# TWO CREEKS NORTH SUBDIVISION MASTER DEVELOPMENT PLAN

Re: Two Creeks North Master Development Plan, **MDP # 011-06**

The City Staff Development Review Committee has reviewed the Two Creeks North Master Development Plan, **M.D.P. # 011-06**. Please find enclosed a signed copy for your files. Your plan was approved for acceptance; however, please note the following conditions:

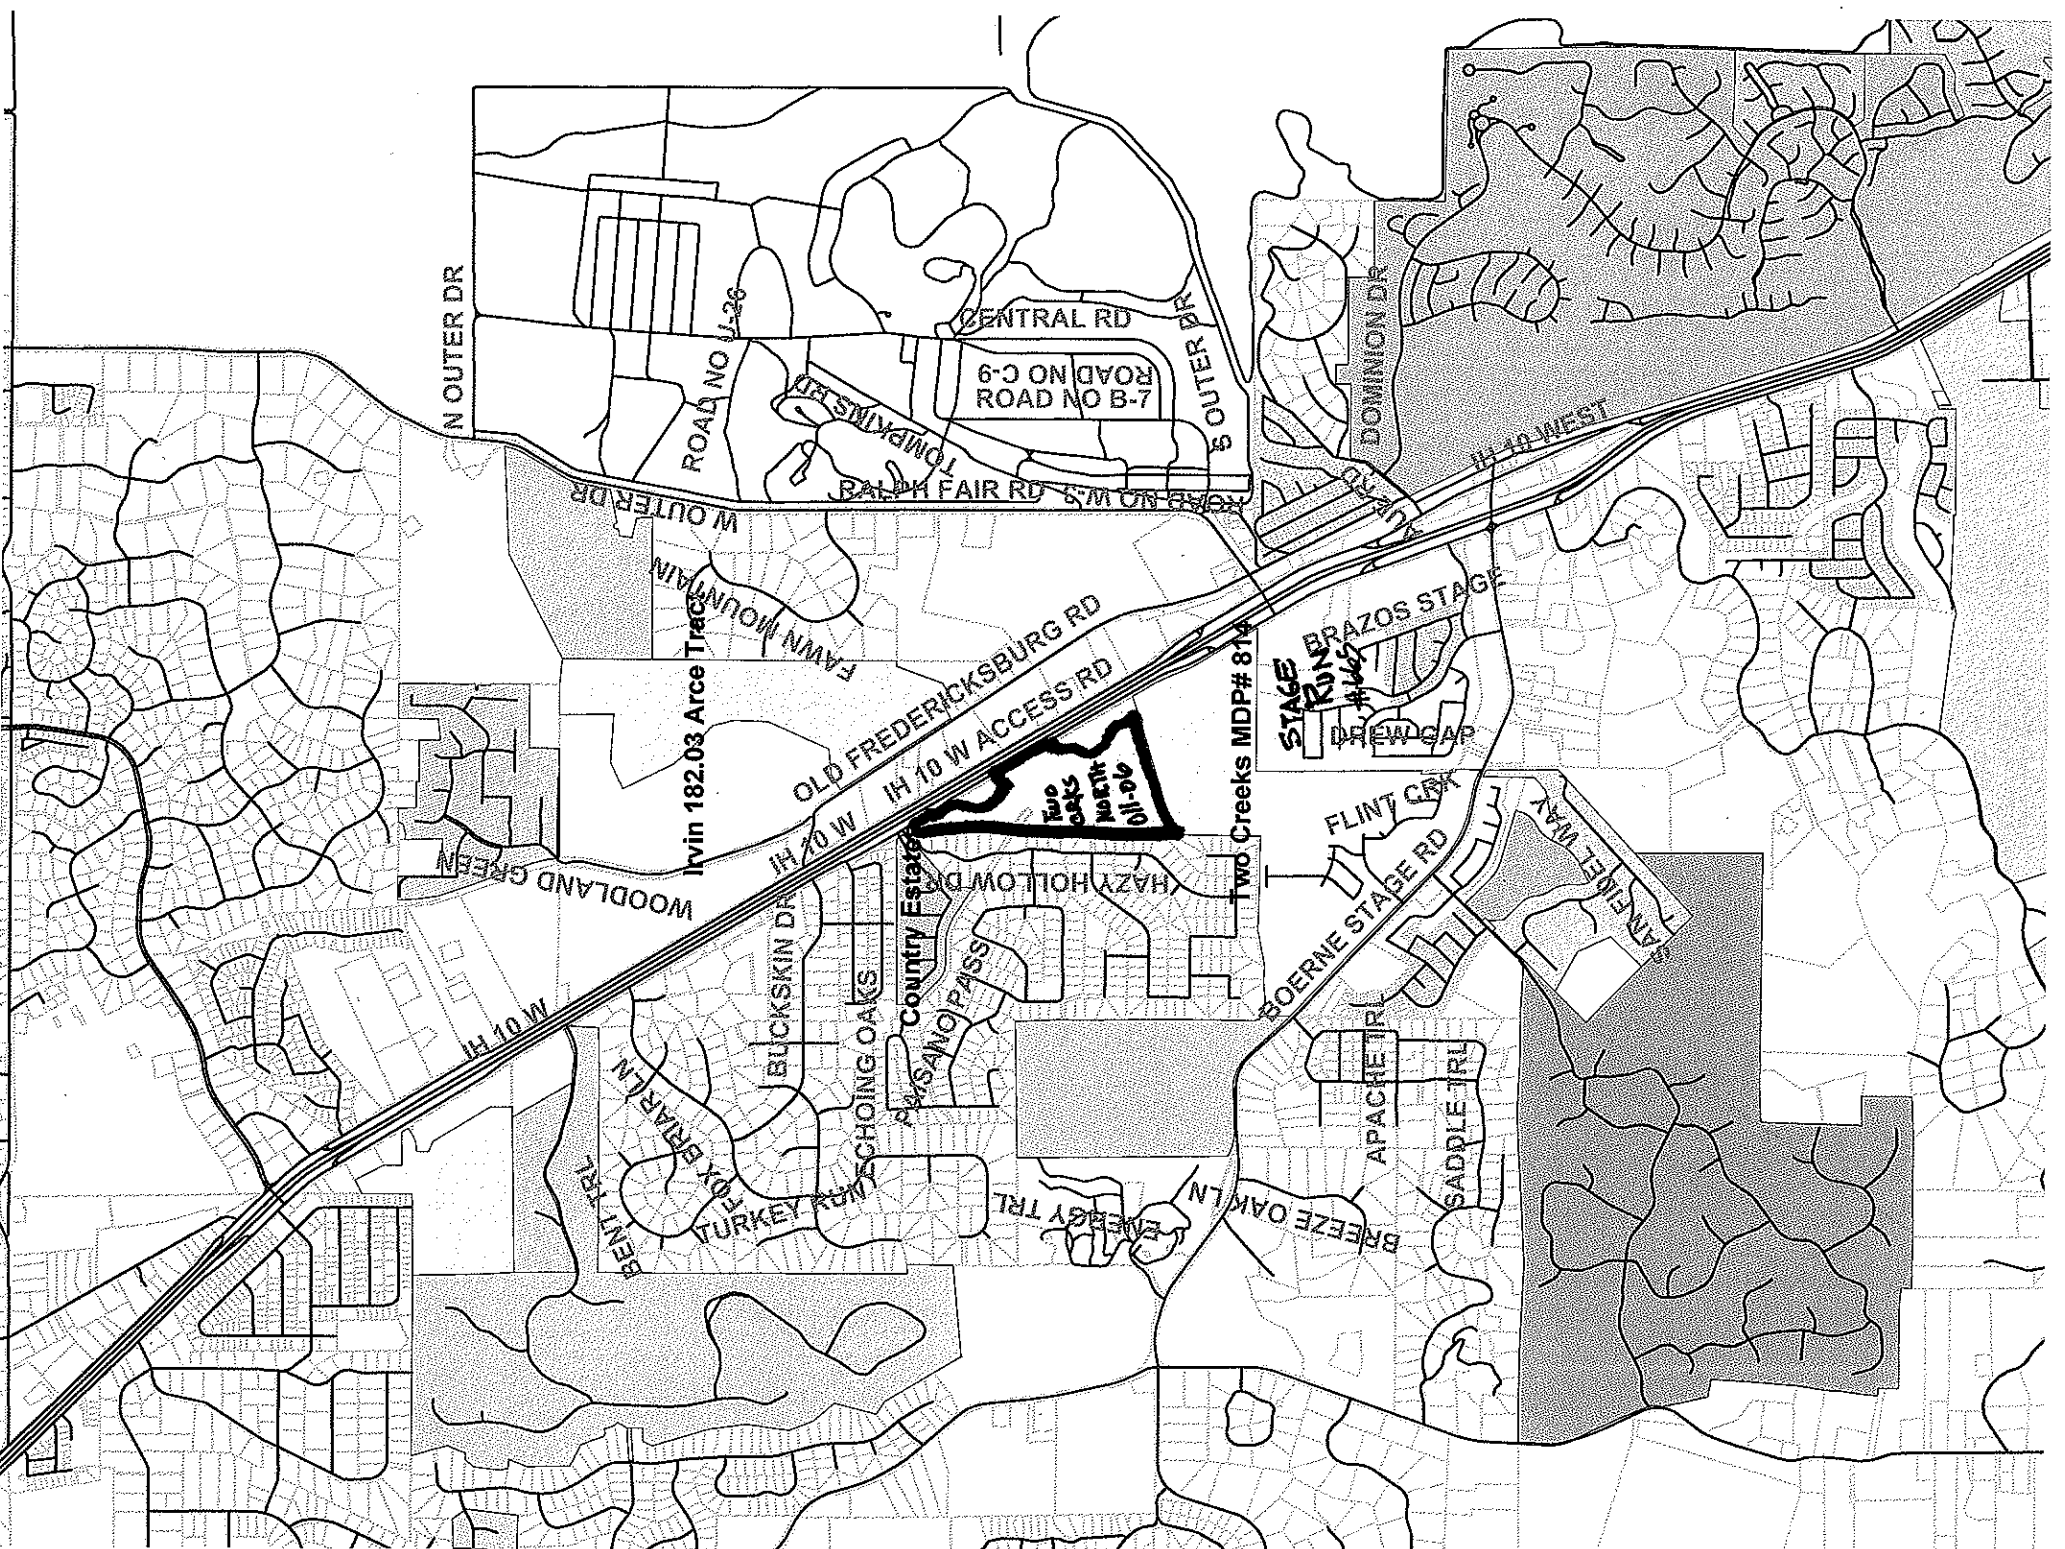
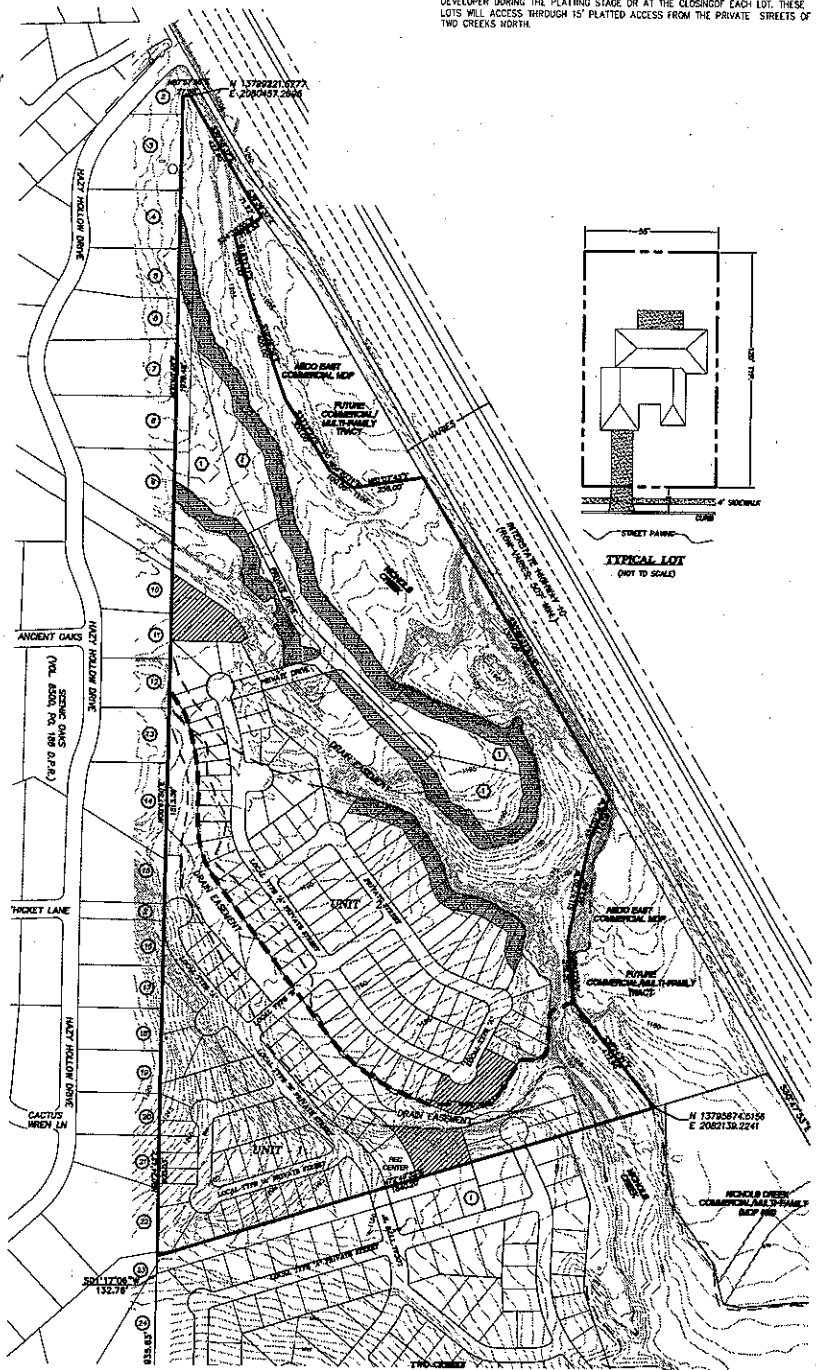
1) Sidewalks are to conform to UDC 35-506(q). The typical section for a Local Type B  
needs to show a six foot sidewalk adjacent to the curb.

- LABEL IHD & SHOW DIMENSION to q and FRTg Rd.
- LABEL THE SCENIC OAKS Subd, LABEL STREET NAMES
- IN Unit-1 <sup>HAS</sup> THERE IS A CUL-DE-SAC, WHICH PROJECTS TO TWO CREEKS  
MDP #814-A, THE MDP WILL HAVE TO BE AMENDED TO SHOW ~~IT~~  
~~CONNECTING INTO~~ THE ROAD.
- WILL ~~NEED~~ NEED TO DECLARE NOW IF IT WILL BE AN ENCLAVE ~~AND~~
- IT WILL NEED TO SHOW A GATE DETAIL.
- WILL NEED TO SHOW THE ACCESS TO THE RESTRICTED SINGLE FAMILY Lot.

1. You will have to declare at this time if it is enclave.
2. The engress projecting into the restricted single family residential lots shall be shown as a road. 35-B101(c)F(9)
3. Show the lots in the restricted residential area. 35-202(f)

1. Label IH10 W and show the dimensions on the frontage road.
2. Label the Scenic Oaks Subdivision and label the streets.
3. Unit -1 has a cul-de-sac projecting on to Two Creeks MDP # 814-A, the MDP was not approved with that projection of road going into  
 Two Creeks North. The MDP # 814-A will have to be amended.
4. You will have to declare at this time if it is to be an enclave.
5. If it is enclave you will have to show a Gate Detail.
6. Need to show the access to the restricted single family lots.

*Response: We are currently amending the Two Creeks Subdivision MDP and PUD plans to reflect this change.*

*Response: A PUD Plan will be submitted.*

*Response: Two Creeks North will be part of a PUD plan.*
